**Addendum No. 2**  
Page 1 of 1

**TO:** Prospective Bidders  
**SUBJECT:** Addendum No. 2  
**PROJECT NAME:** Parking Lot Improvements  
**JJC PROJECT NO.:** B20019

**PAVEMENT SECTION**  
NOT TO SCALE

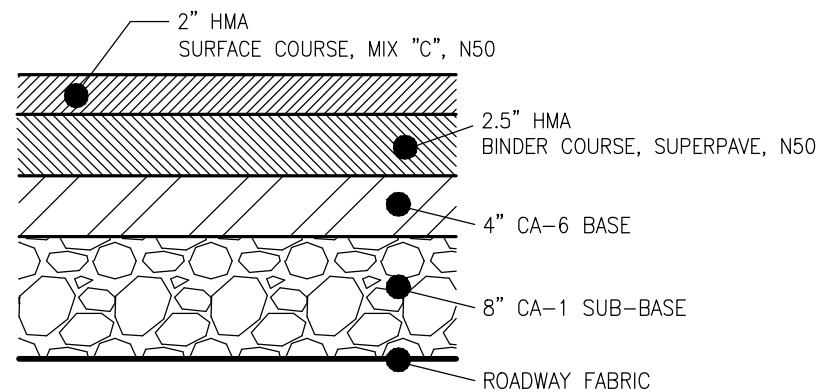
1. On the 'Pavement Section' Detail for the Mill and Replace, it shows a leveling binder. Is a leveling binder required over the entire mill and replace limits – if so, what thickness? Or, is there a tonnage that we should carry in our bid for a leveling allowance?

7. Level Binder: Level binder is mentioned in the Scope of Work document and shown on the typical section for HMA pavement, but there is no information given as to the type or thickness of level binder desired. Please clarify.

**Answer:** *The estimated quantities have been updated to include leveling to be carried in the base bid. We are also requesting the unit price of leveling binder to potentially adjust this number up or down based on field conditions.*

***Answer:*** The estimated quantities have been updated to include leveling binder to be carried in the base bid. We are also requesting the unit price of leveling binder to potentially adjust this number up or down based on field conditions.

**FULL DEPTH PATCH**  
NOT TO SCALE

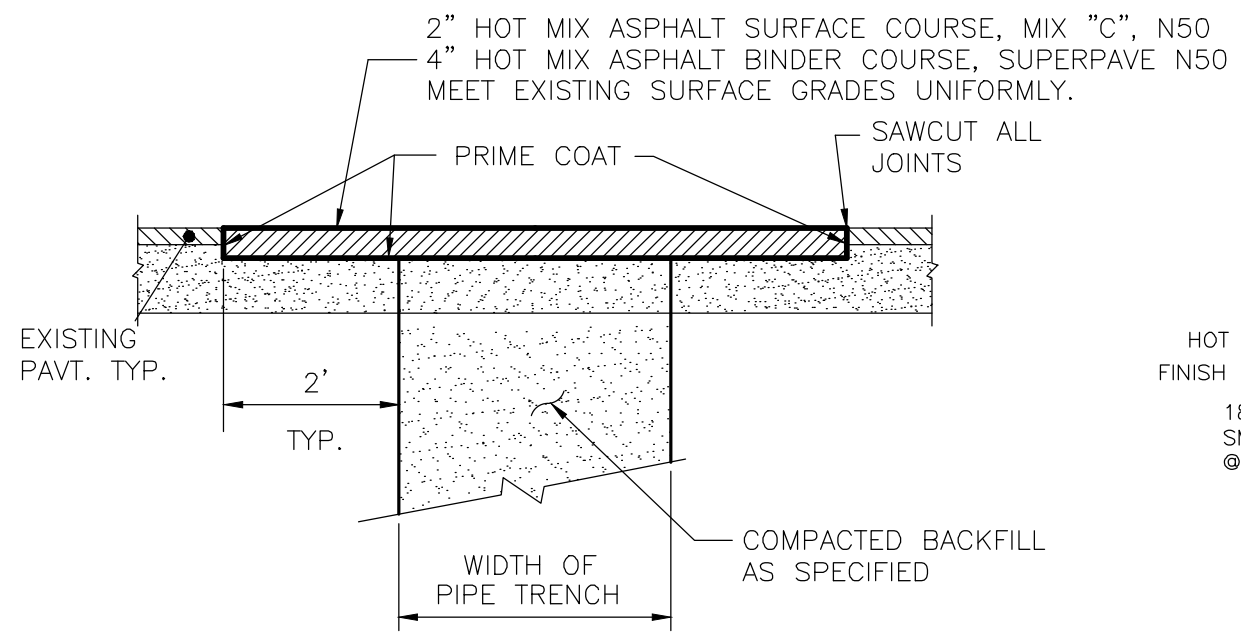
2. What is the scope of work for Pay Item # 2 for the Parking Lot S6 Improvements – 'Patch base' – 850 SY. We don't see anything referring to binder replacement, an undercut or base replacement on the plans, specifications or details – please clarify.

6. Pavement Patching (Lot S-6): Sheet C2.03 contains the detail titled "Bituminous Pavement Repair" that shows the section of pavement to be replaced above a utility pipe trench. I understand this will be required in the pavement areas under which the new storm sewer is to be installed. My question is this: does this detail reflect what will be required to repair distressed pavement areas that are NOT over utility trenches? The detail shows a total depth of 14" of HMA. Typically parking lots have somewhere around 5-6" HMA.

**Answer:** *A detail has been provided for "Full Depth Patch". The line item has also been updated on the estimated quantities to match the detail name.*

***Answer:*** The "Bituminous Pavement Repair" detail on Sheet C2.03 has been modified and is associated with repair above utility trenches. A "Full Depth Patch" detail has been added to sheet C2.03 depicting the scope of repair for distressed pavement.

**BITUMINOUS PAVEMENT REPAIR**  
NOT TO SCALE

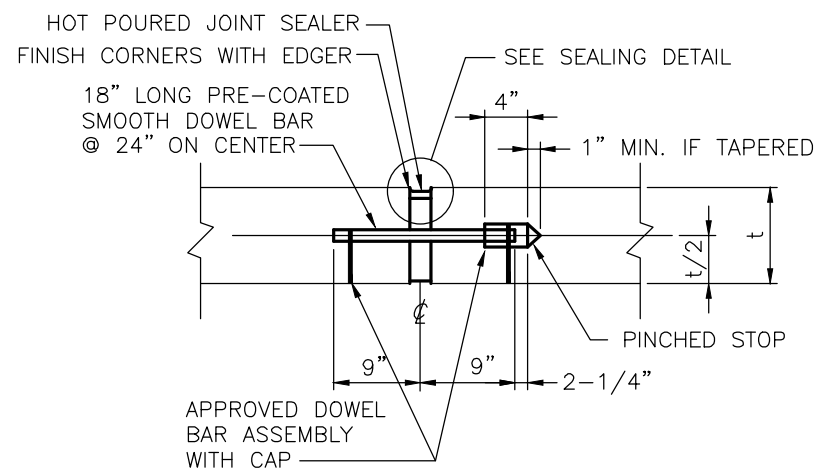
3. Please confirm 10-inches of BAM – Bituminous Aggregate Mixture is required at the new sewer/RCP. There are two details referring to the pavement restoration over pipe trenches.

**Answer:** *The "Bituminous Pavement Repair" detail on Sheet C2.03 has been modified.*
4. Please clarify the scope of work for Item # 3 for the Entrance Improvements – 'Grade and Repair Aggregate Base' – specifically the 'repair' portion of this pay item.
